Subject: Supplement No. 1
Geotechnical and Geologic Investigation
Lots 11, 19, and 20, Block 15, Tract No. 7803
1749 and 1751 Malcolm Avenue and 1772 Glendon Avenue
Los Angeles, California

We are pleased to submit this Supplement No. 1 report responding to the City comments. The original report of geotechnical and geological investigation report for the subject project was issued by this office on July 21, 2015.

This submittal is in response to comments in a Geology and Soils Report Correction Letter dated August 19, 2015 by the Grading Section Of the Department of Building and Safety of the City of Los Angeles (Log # 89430). For convenience, we have enclosed a copy of the City Review Letter with this Supplement No. 1 report. Our responses also incorporate verbal discussion of the comments between the undersigned geologist and Mr. Schneidereit of LADBS as well as with Mr. Brian Olson of the California Geologic Survey.

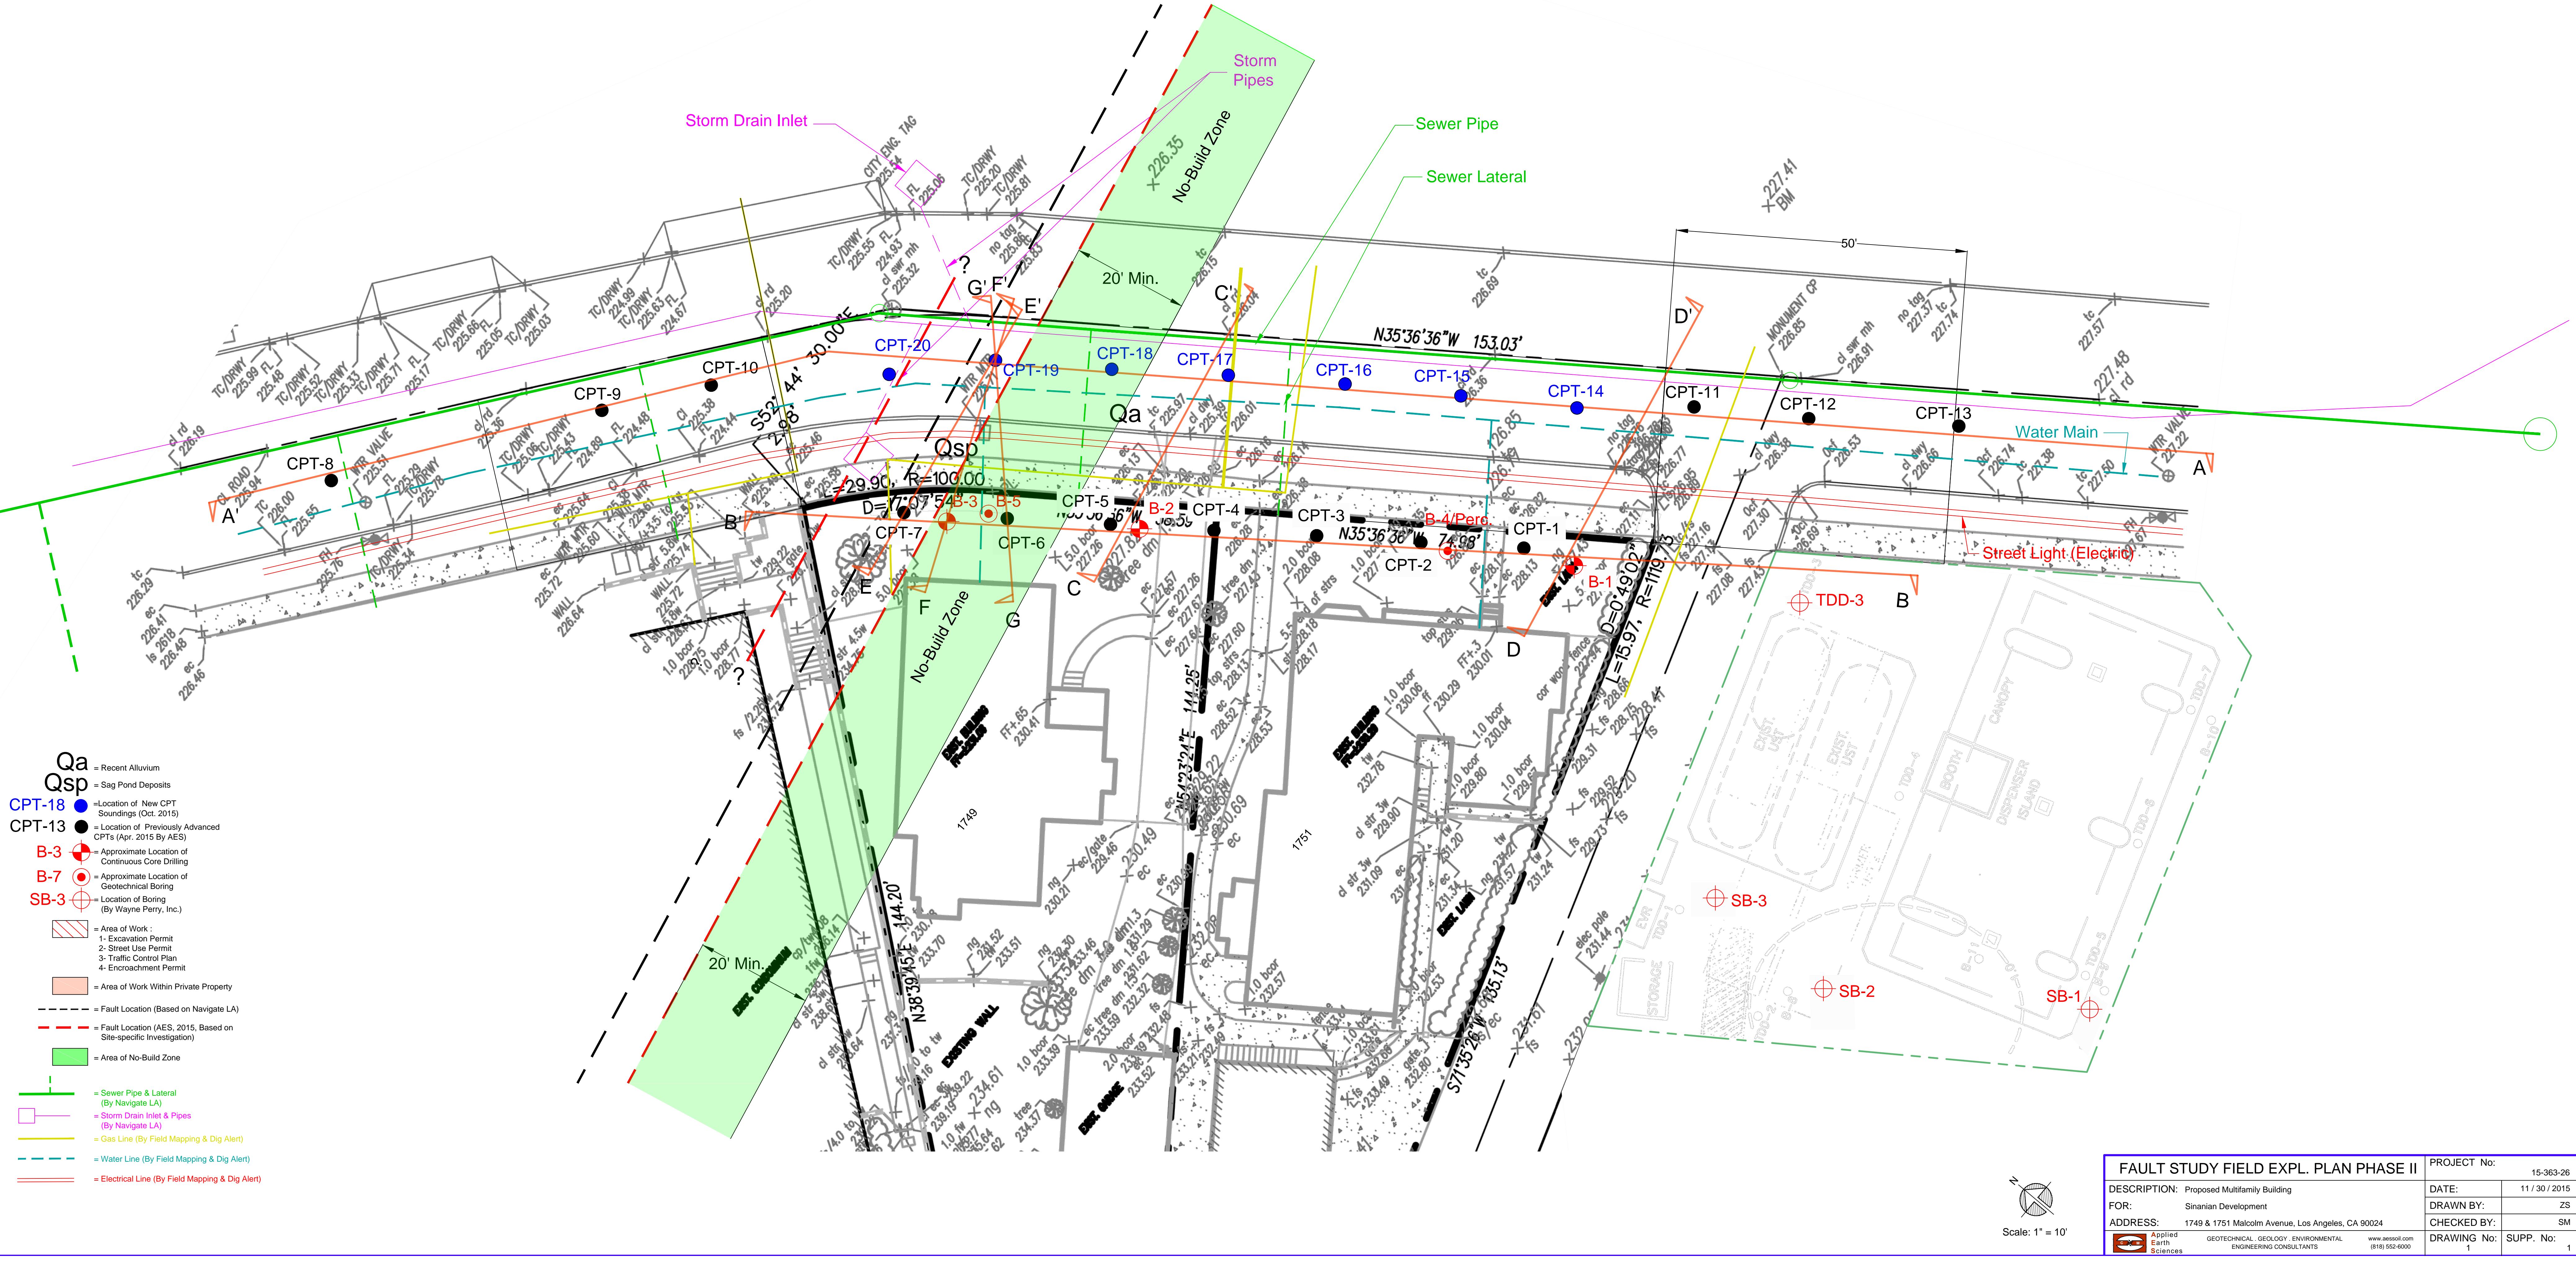
1. In order to respond to this comment, and as requested, additional exploration was advanced along Malcolm Avenue. Seven additional Cone Penetrometer soundings were advanced along the street, CPT-14 through CPT-20, on October

See the Drawing No. 1 for the locations of the new CPTs. The new CPTs were advanced in the street between old CPTs 8-10 on the north and CPTs 11-13 on the south along the same alignment. These additional CPTs have allowed for better resolution of the fault location and orientation.

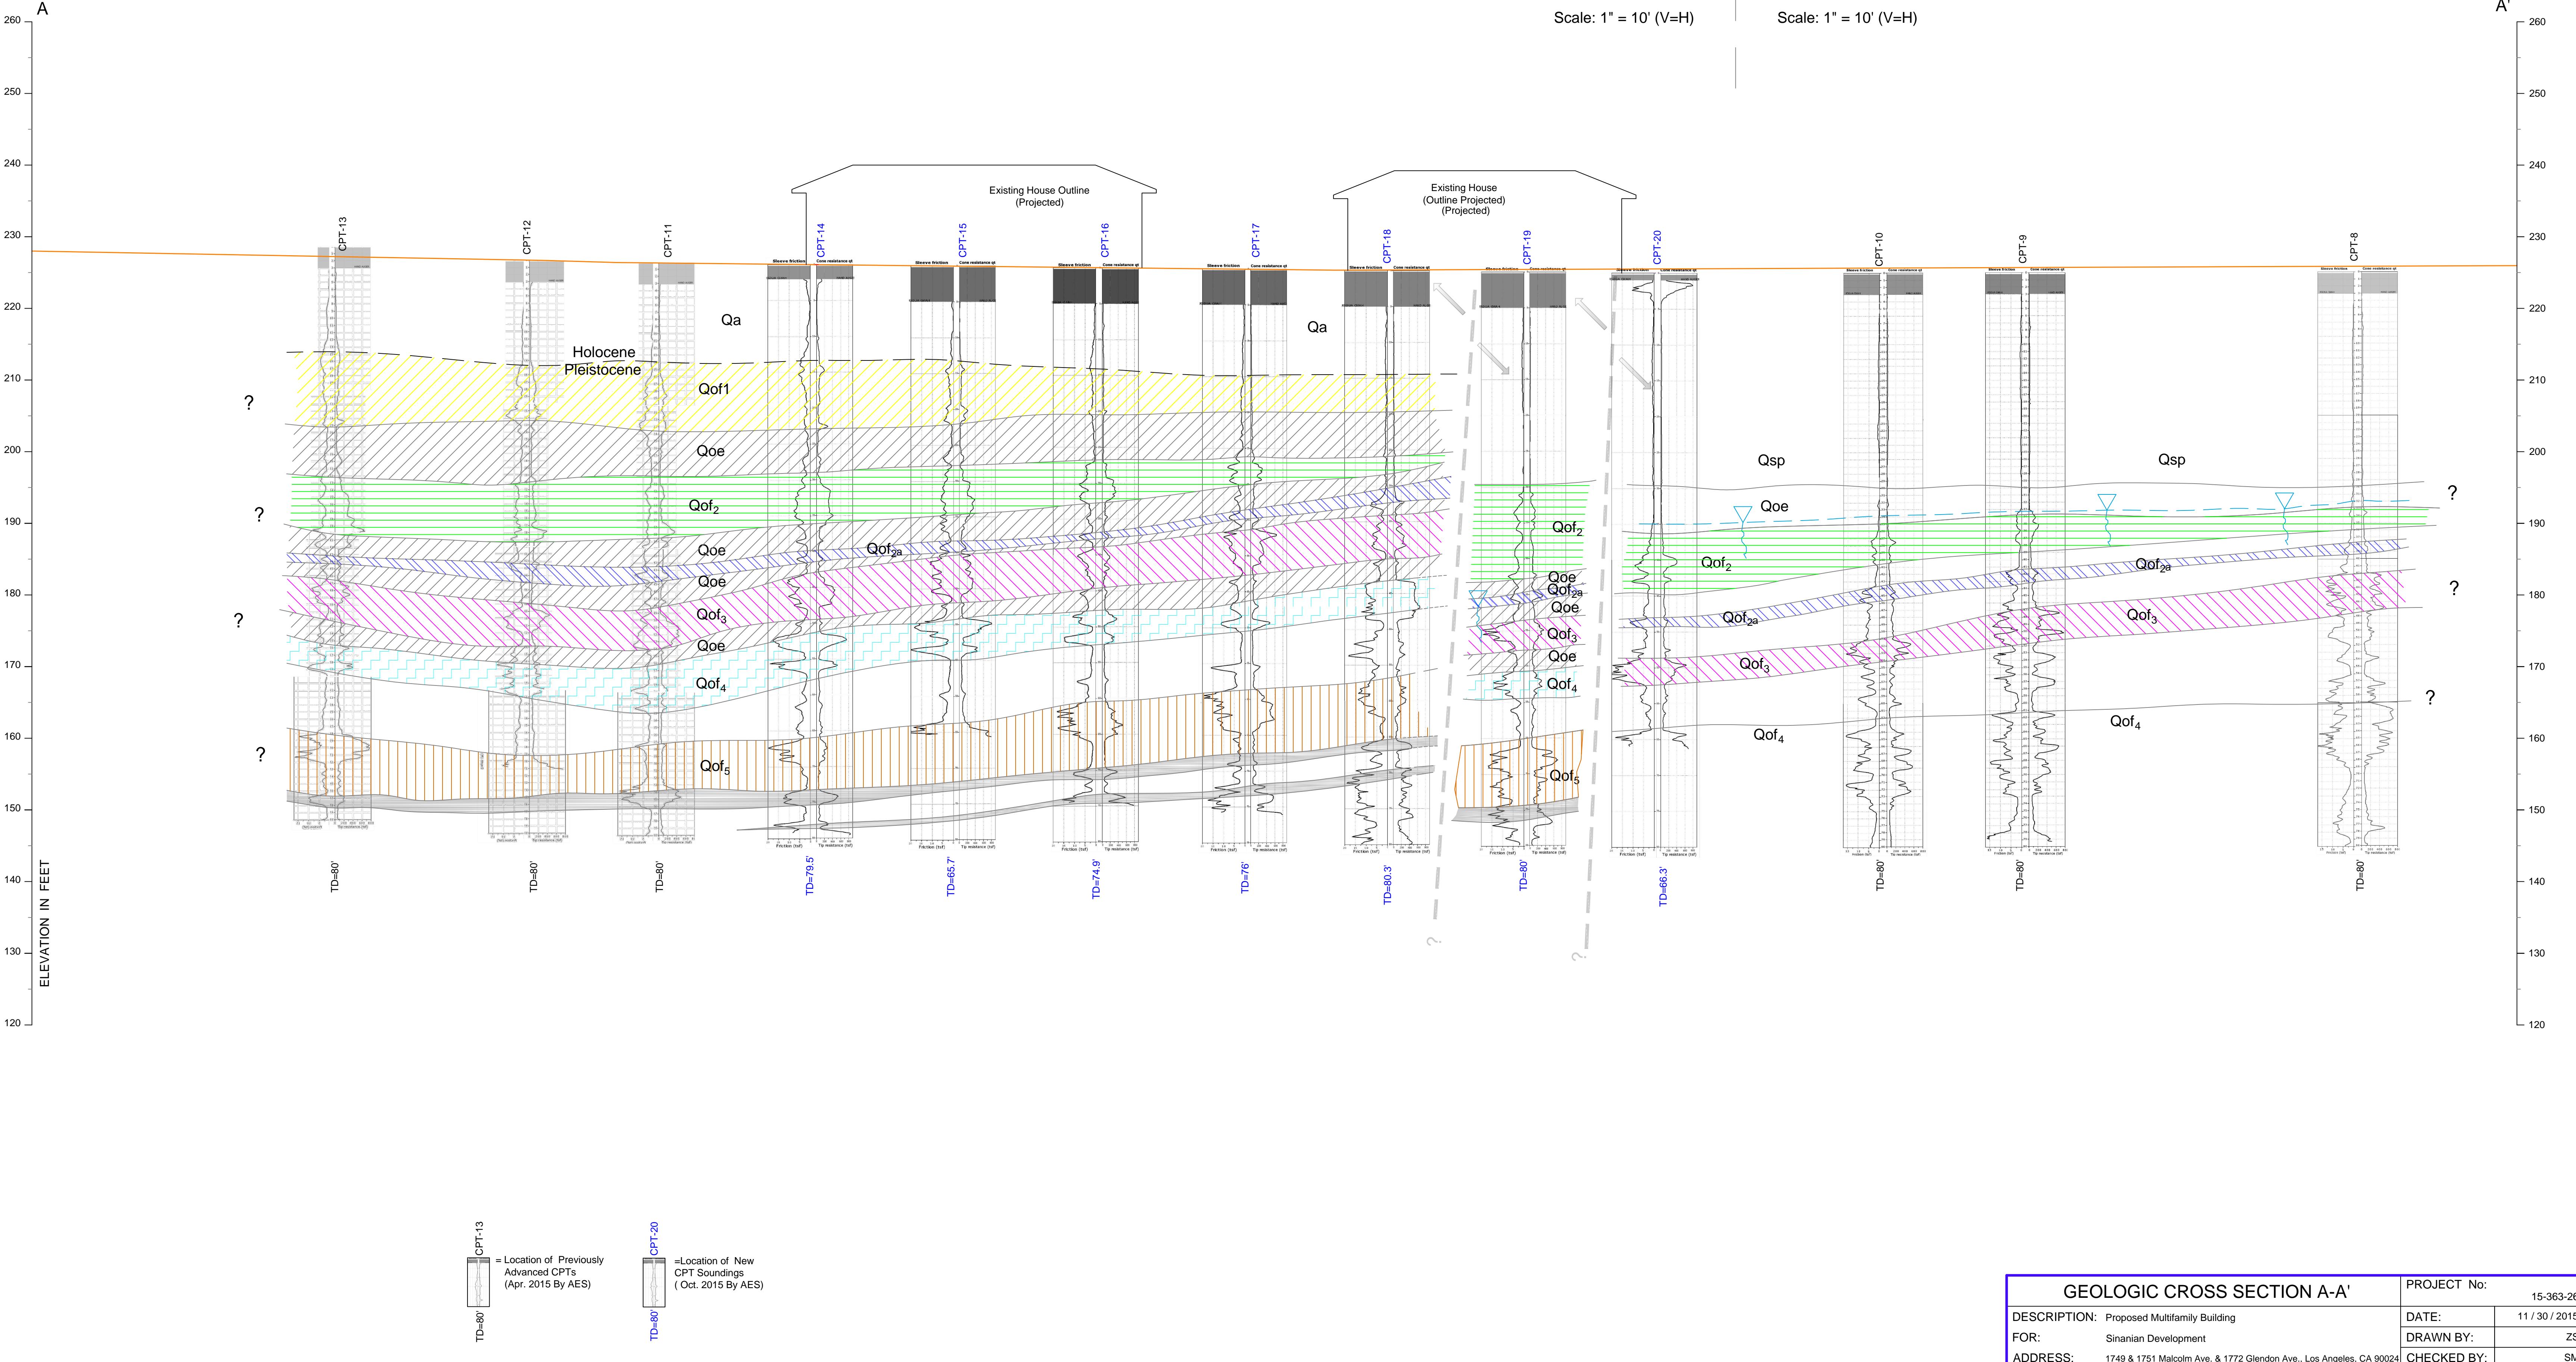
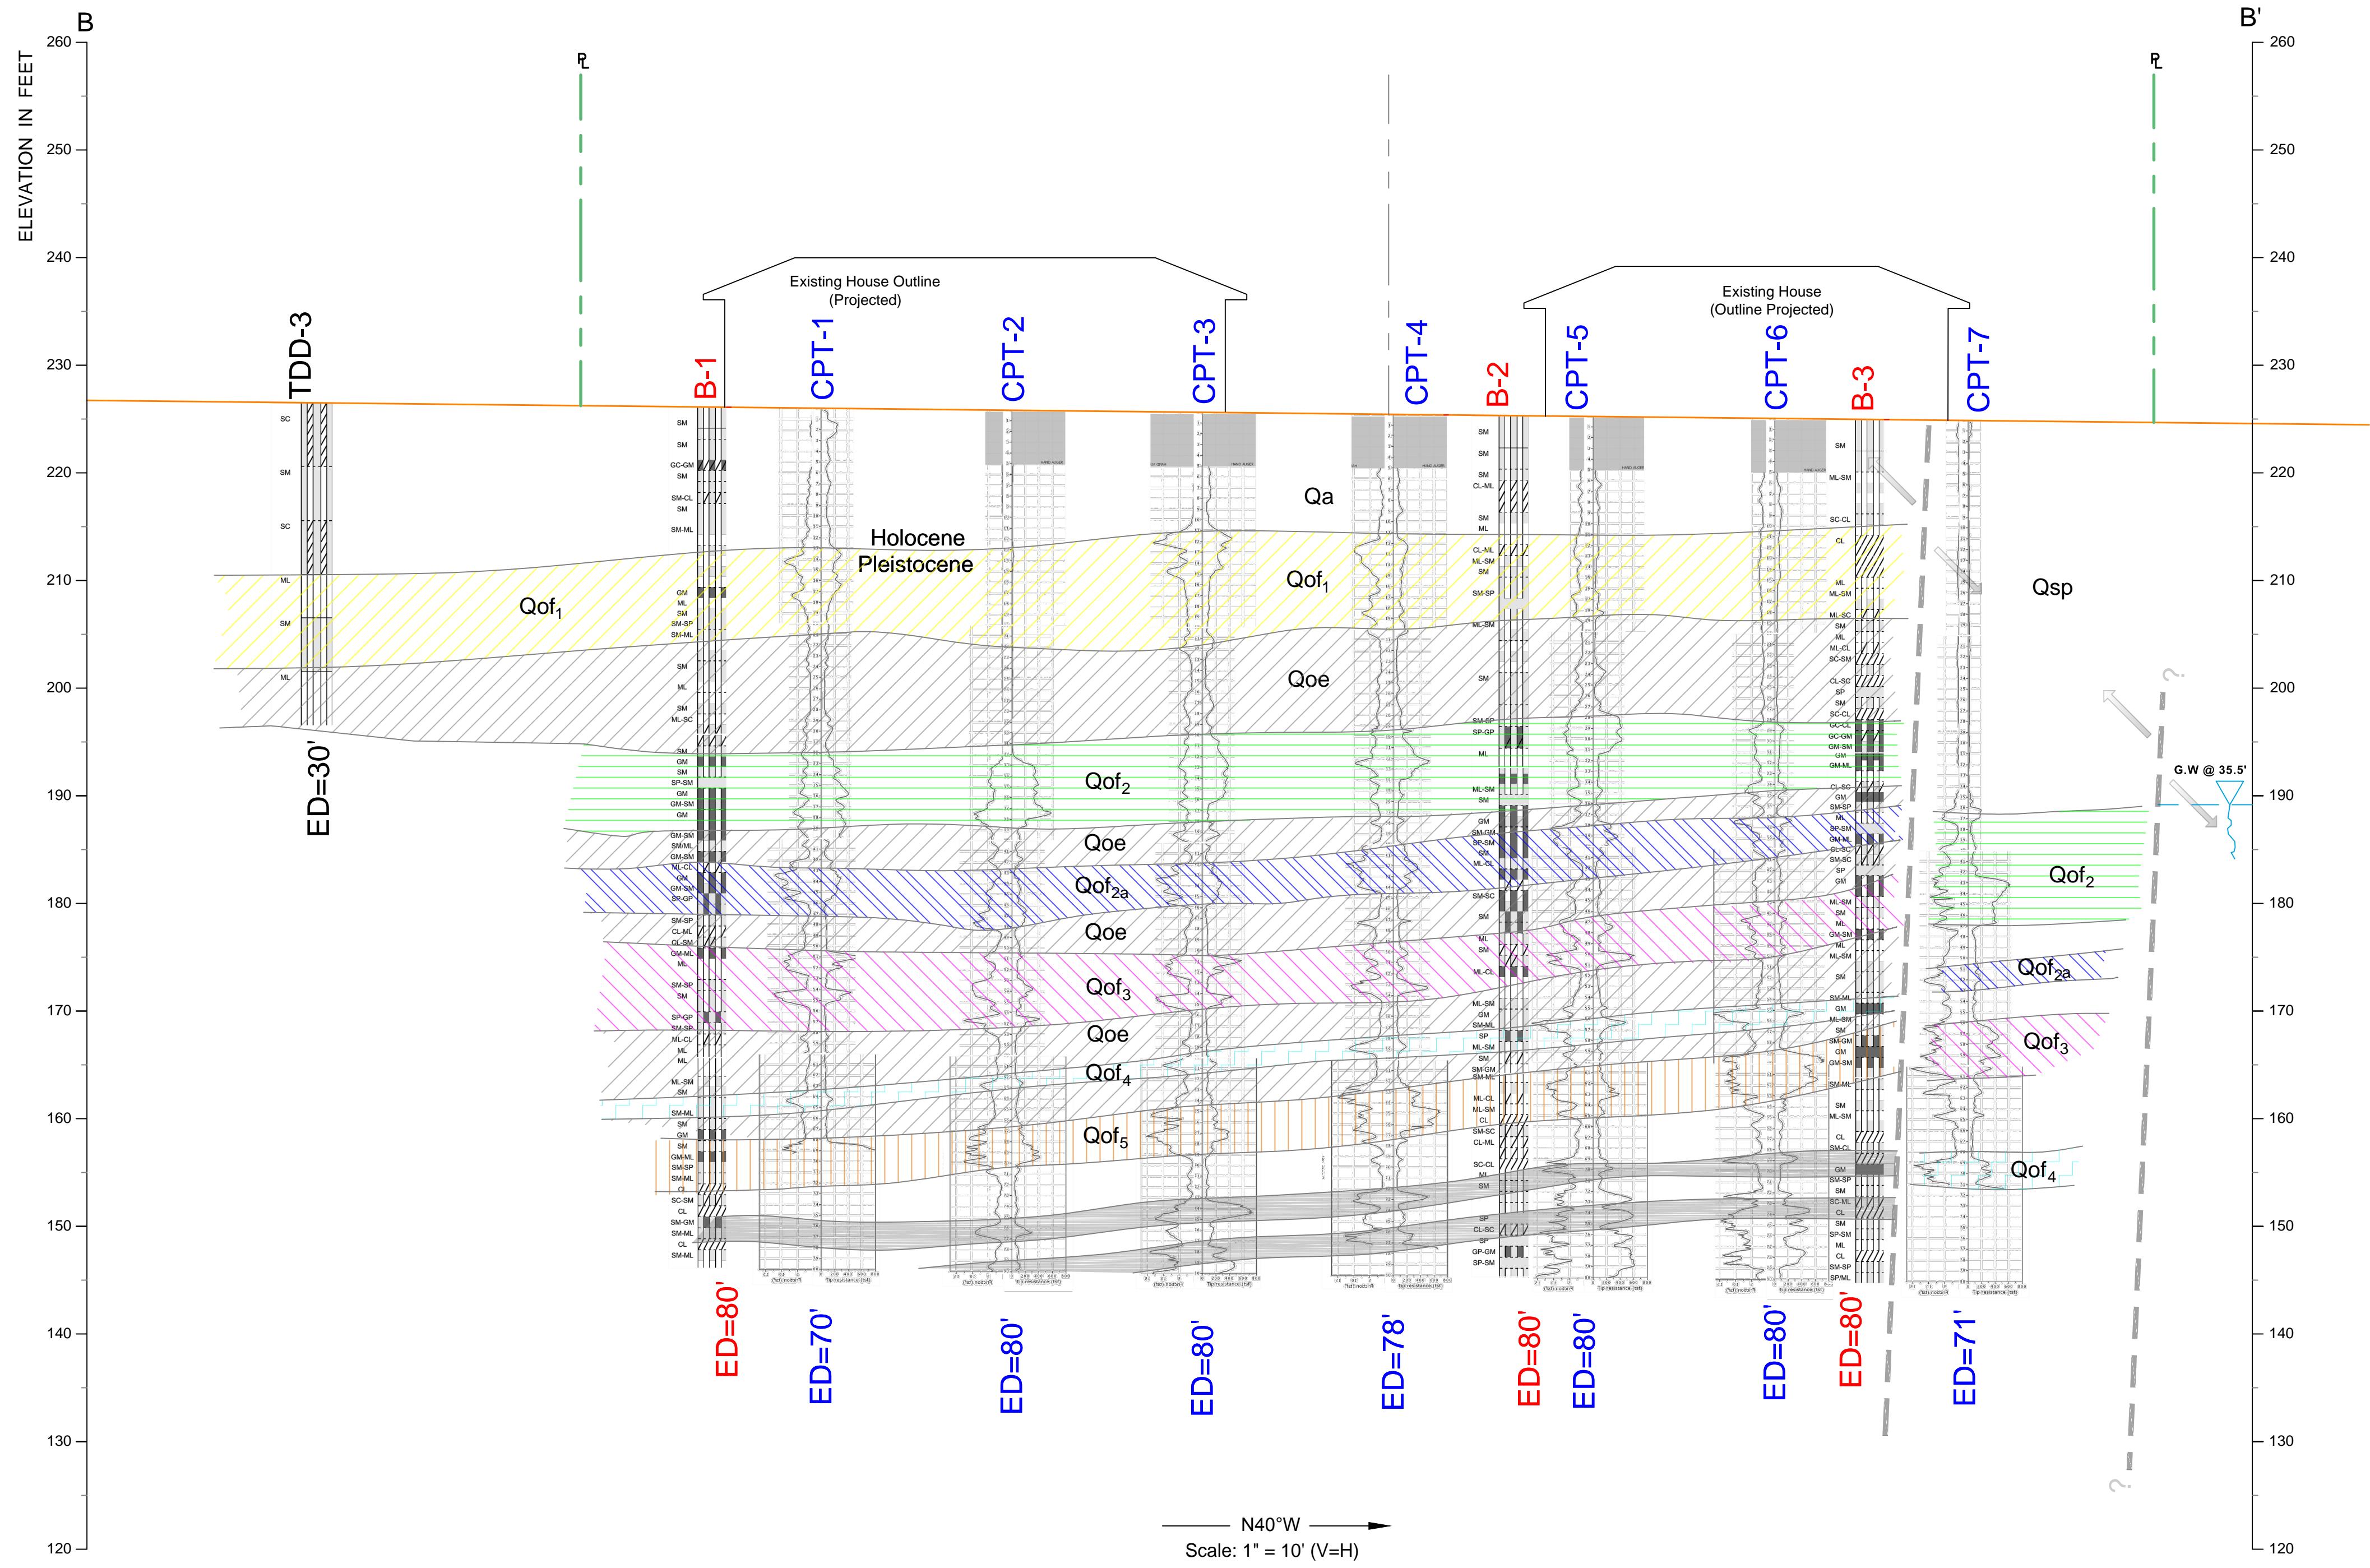
1. The proposed 10-ft. setback from the active fault splay appears small given that the fault was identified at only one location and there is no direct evidence of the orientation of the fault. In addition, the fault trace may be closer to B-3 than estimated. Additional exploration is required to determine the fault's trend in at least two locations to warrant the recommended reduced setback. Alternatively, a larger setback could be recommended.
2. Provide more detailed discussion on the stratigraphic correlation from CPT-13 to B-3. The upper soils of CPT-11 to CPT-13 appear more fine-grained than the soils observed from CPT1 and B-1. It seems like Qof-1 is missing from CPT-2 (back to fine-grained) and the top of Qof-2 appears to be lower.
3. What is the purple marker bed shown at depth on the northern portion of Cross Section A-A'.

We have revised the main geologic cross section A to include the new CPTs along the street, and have removed the projected geologic Borings 1 through 3. We have included a new geologic cross section B, through the geologic borings and previously advanced CPTs which were advanced through the east portion of the subject property. We have identified the fault location based on cross correlation of CPT logs and boring logs in each of these north-south sections, as well as numerous east-west sections between the two main transects, and this has given us a better resolution of the fault location and orientation.

The subsurface layers as shown in sections A and B appear to be folded due to the proximity to the fault zone. This is more pronounced in the southern portion of the study area. Folding of subsurface strata near faults is common and well documented in the literature.
